FOR: HVAC Replacement
FFA Leadership Center Recreation Hall
Kentucky Department of Education
Hardinsburg, Kentucky

ADDENDUM NO. One (1)

ADDENDUM NO. 1

TO: All Plan Holders
FROM: Studio Kremer Architects
PROJECT: Future Farmers of America Leadership Camp
RECREATION BUILDING
ska# 2023-33.7

4 POWER DISTRIBUTION RISER DIAGRAM
NO SCALE

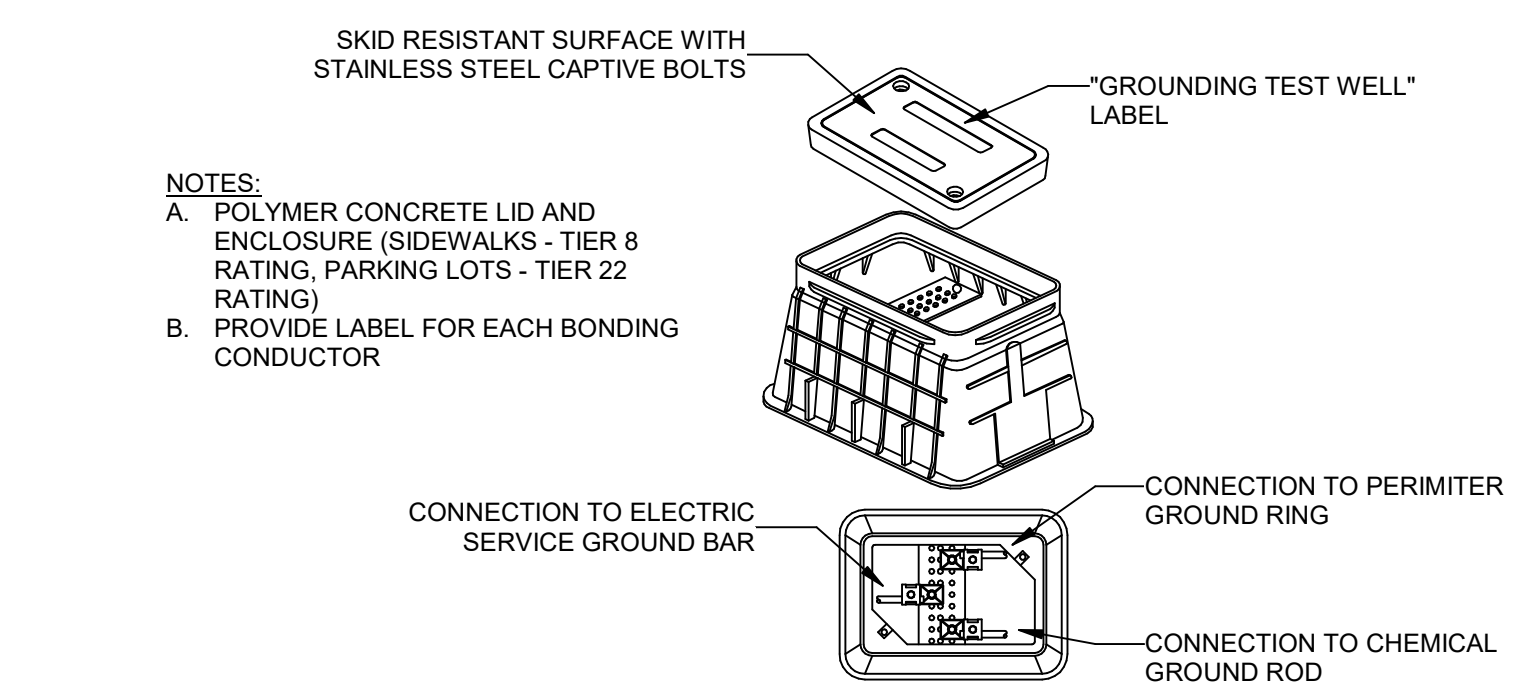
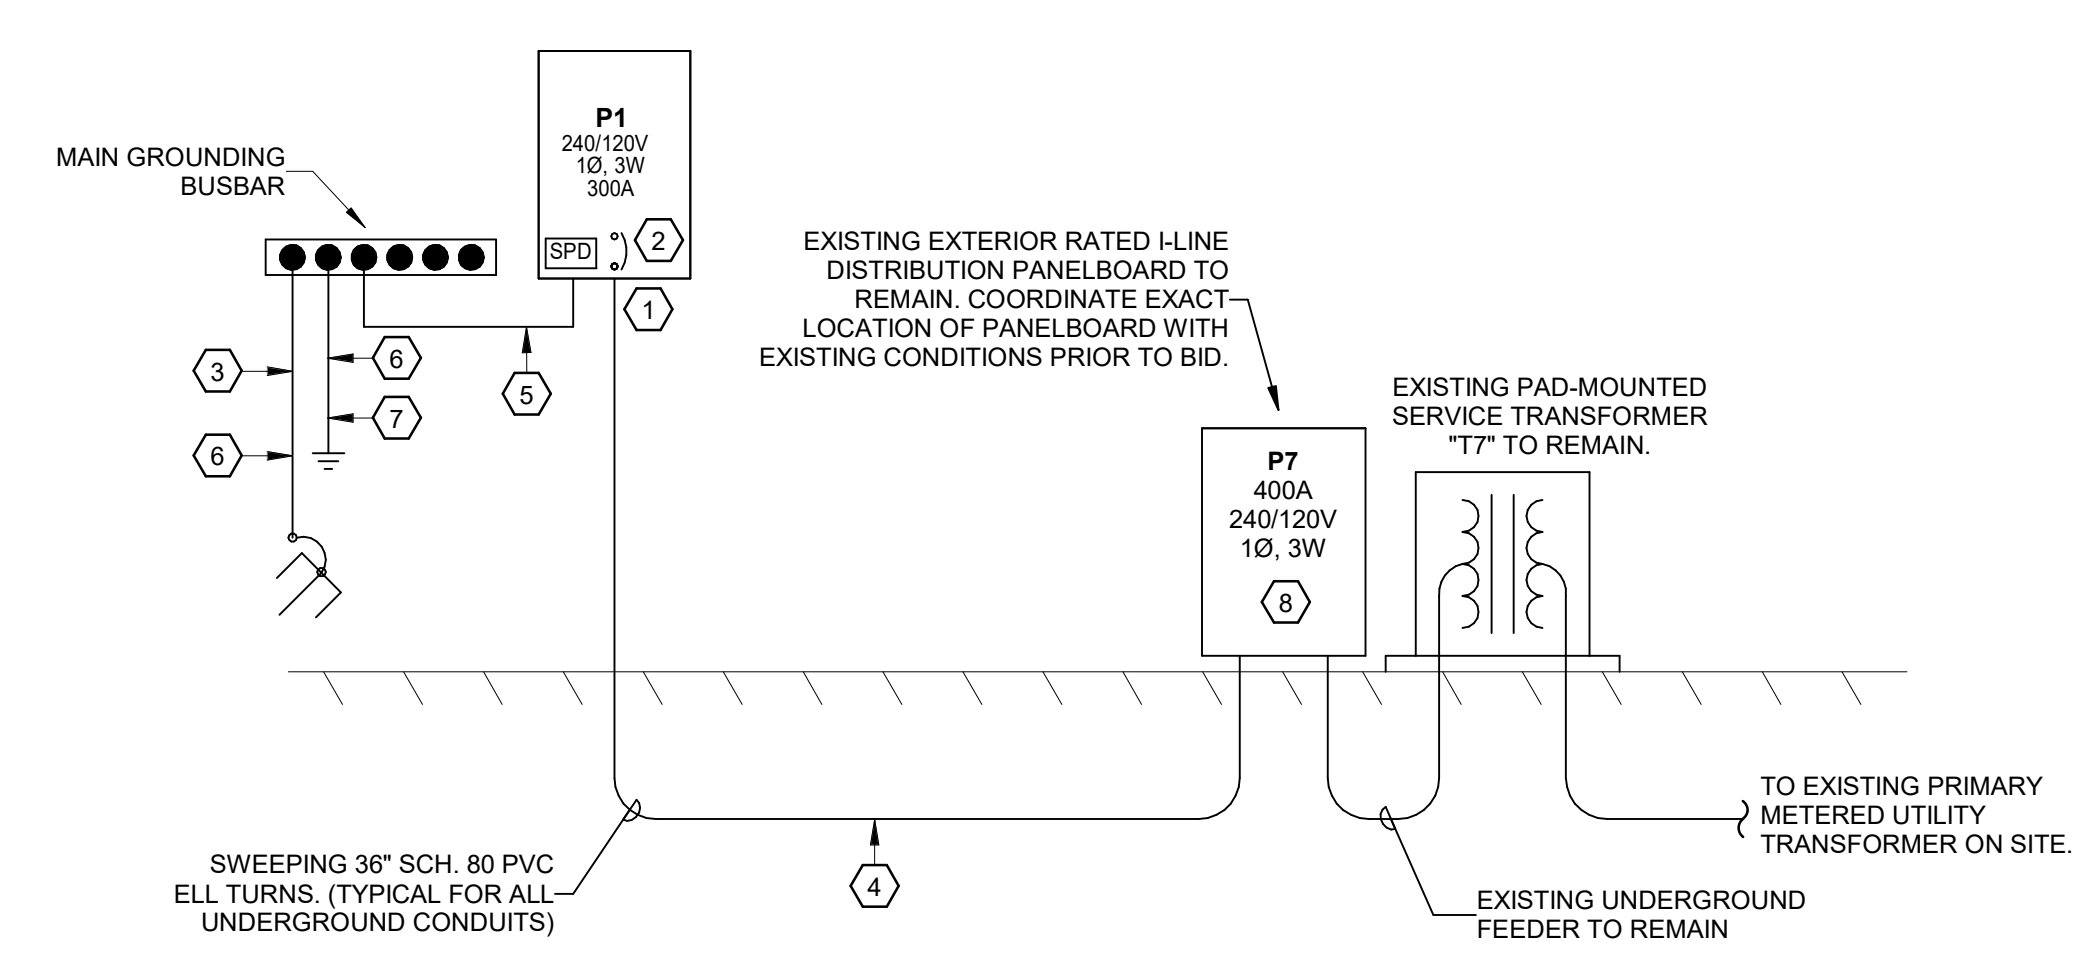
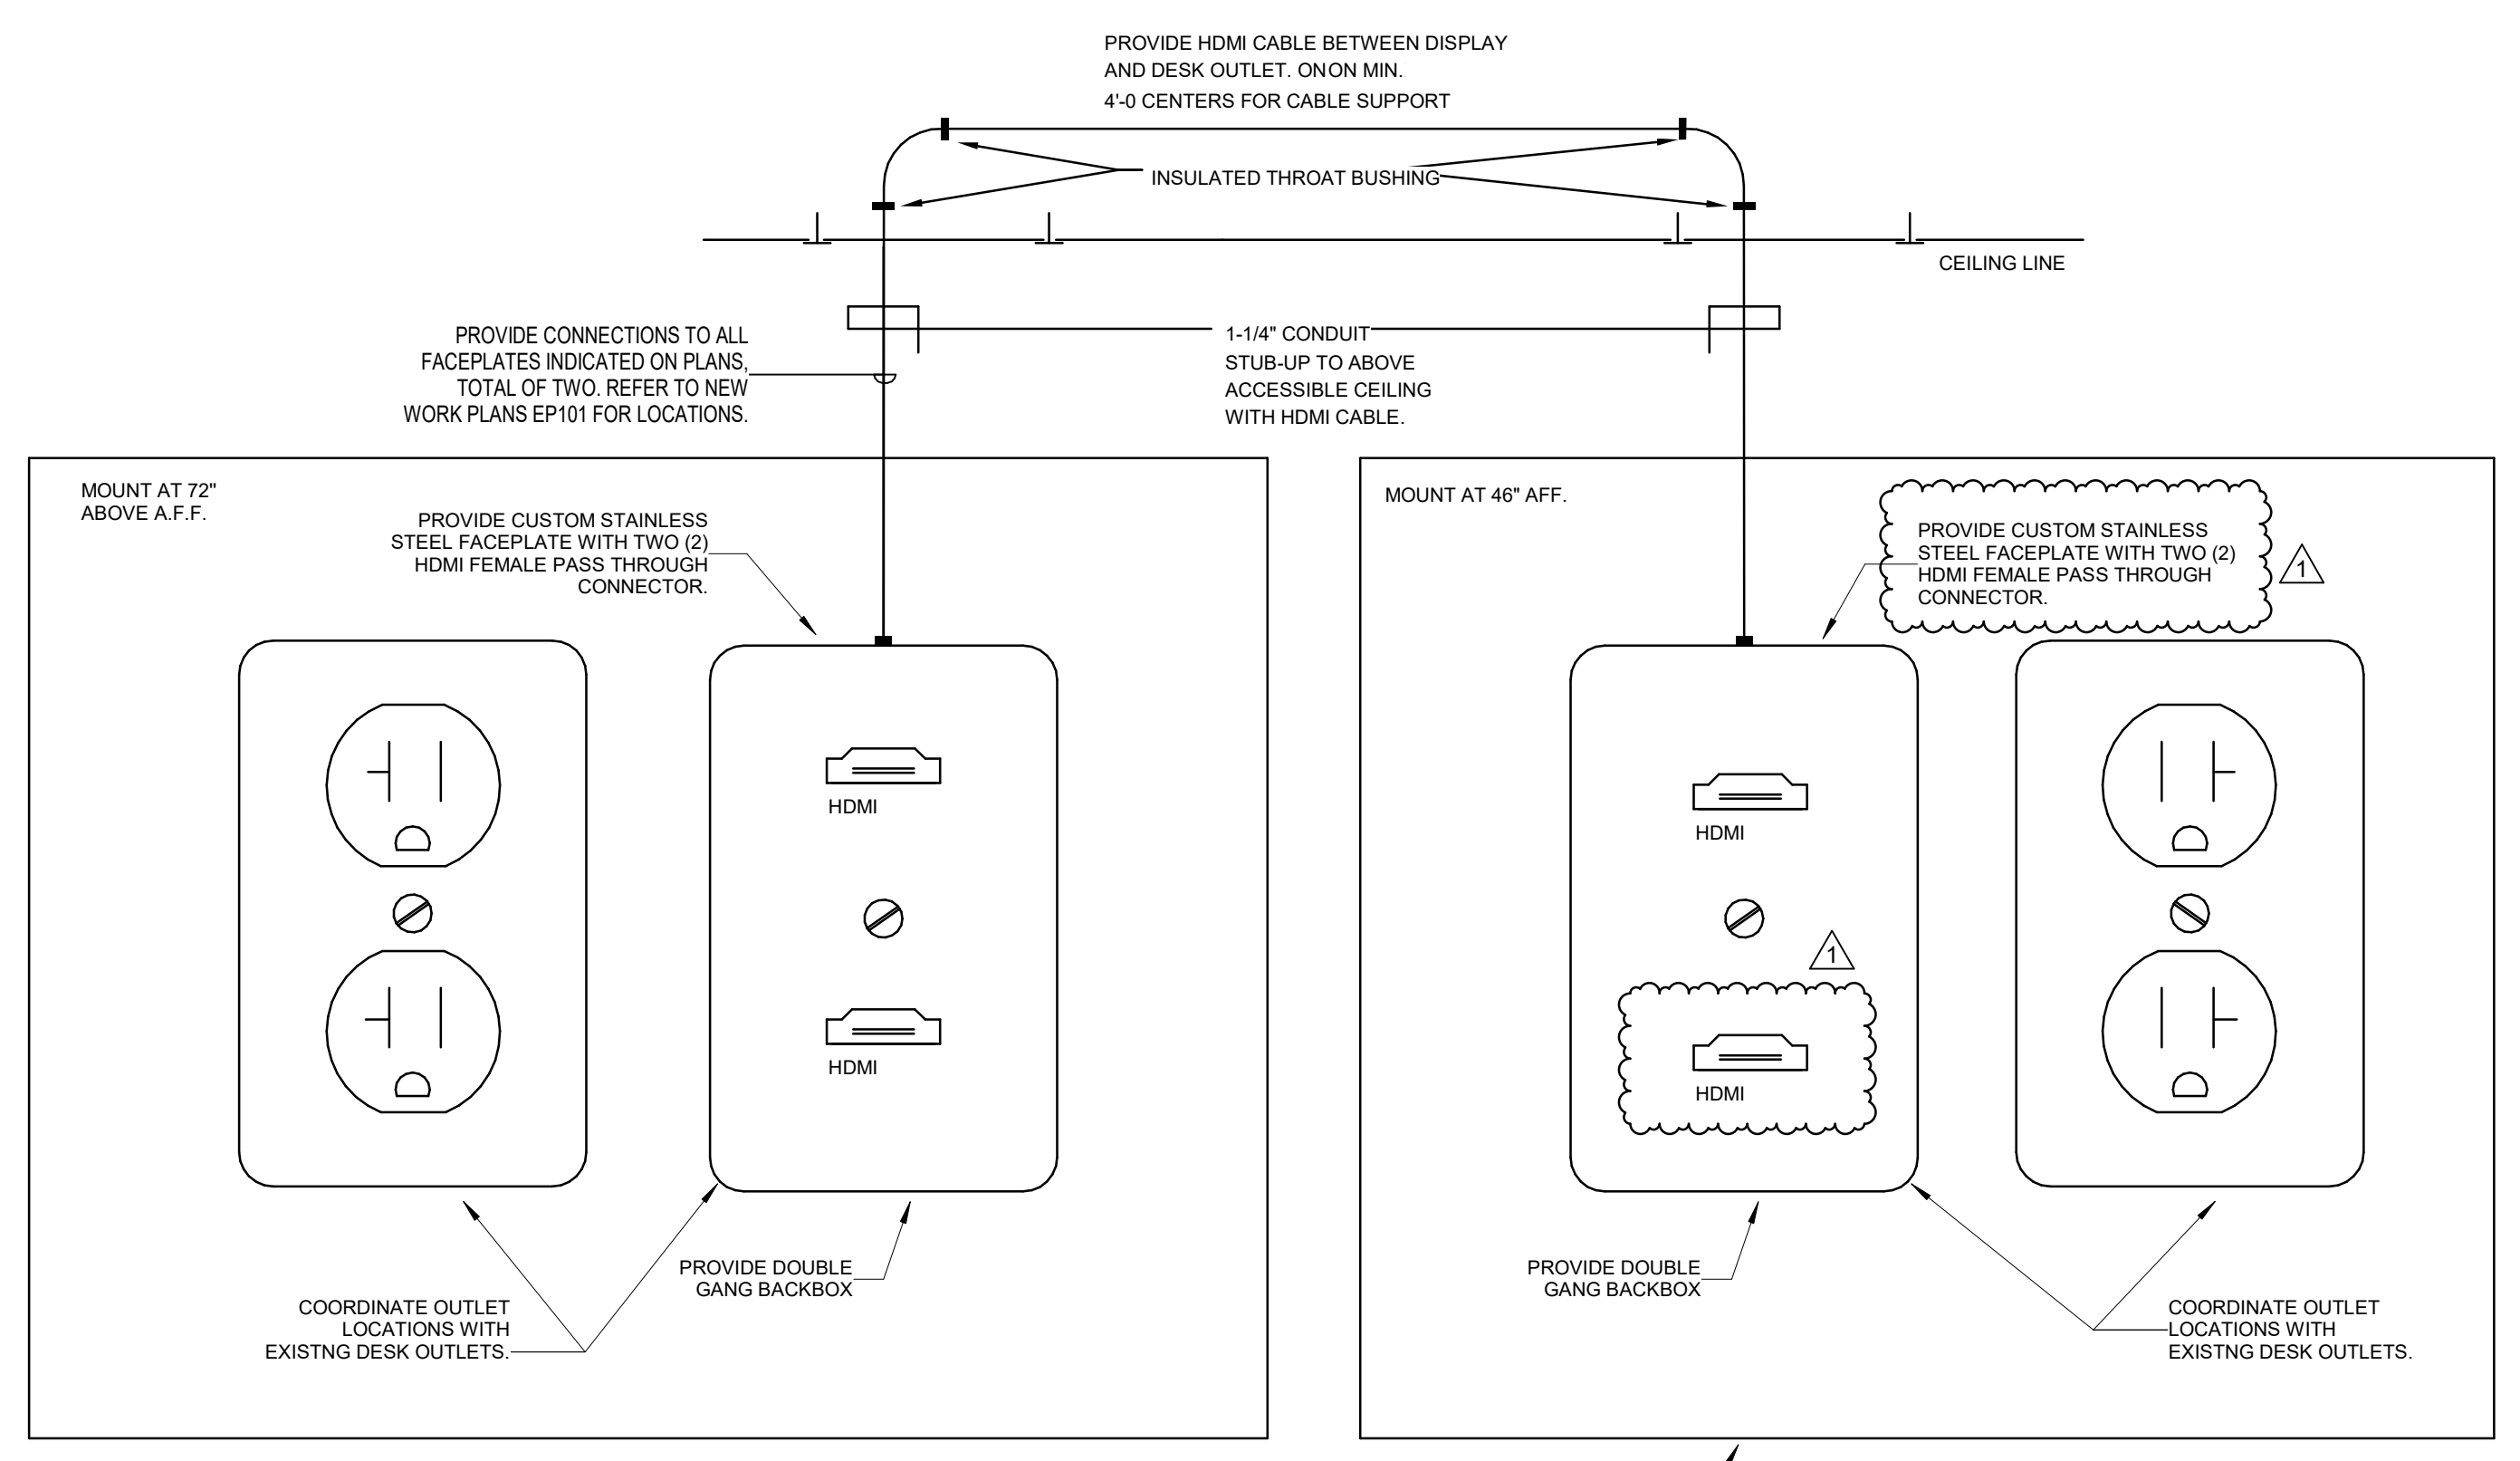
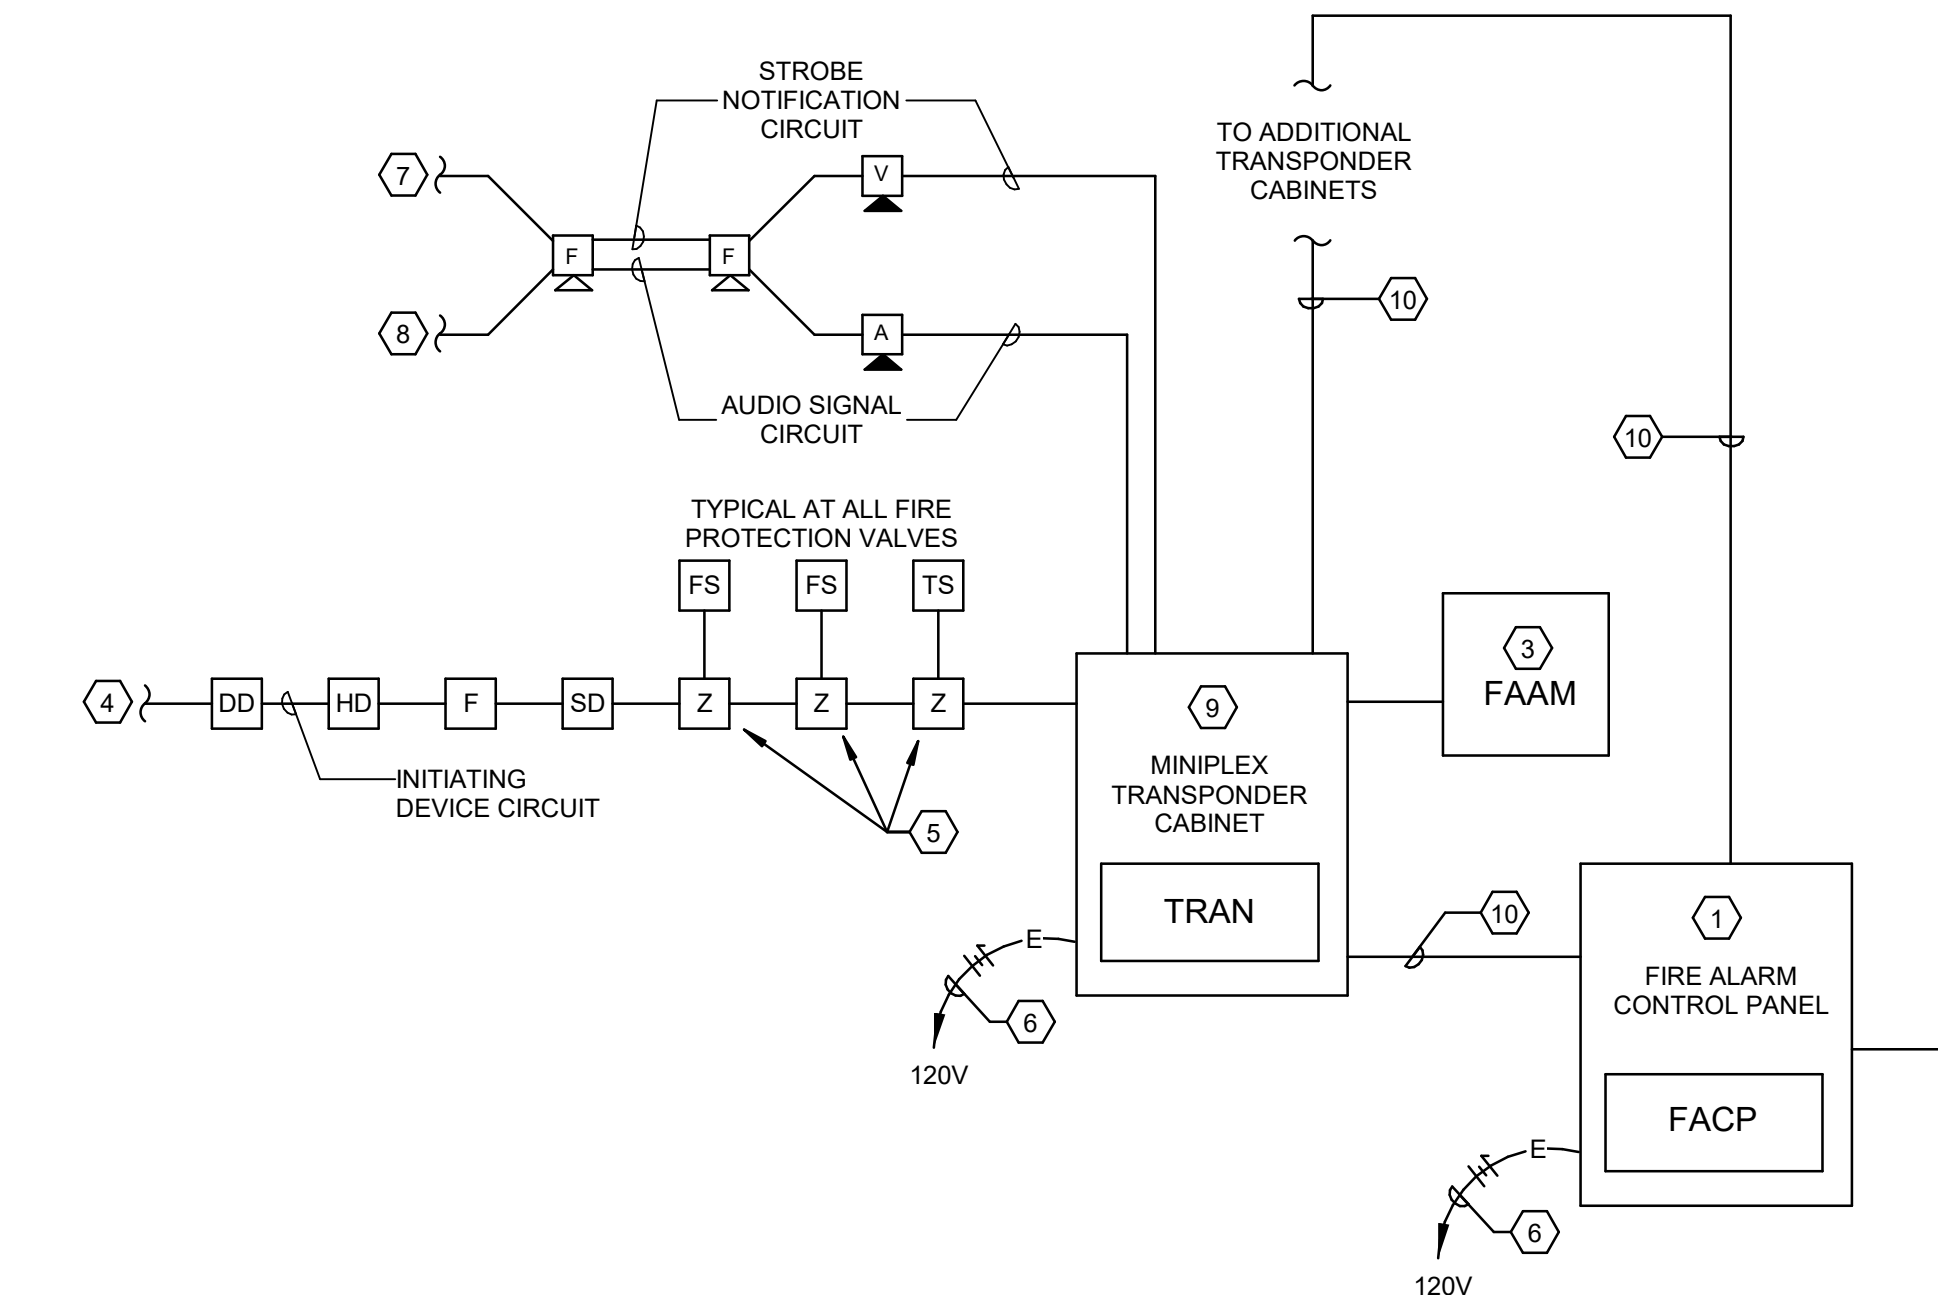
Sheet E-301

CMTA Response: 42".

CMTA Response: underground conduit shall be schedule 80.

CMTA Response: Conduit on the exterior of the building shall be Rigid Conduit. Panel P7 is located on the surface sch 80 pvc can be utilized when turning into panel p7.

CMTA Response: Yes the breaker will fit.

CMTA Response: Yes concrete encase conduits is not required.
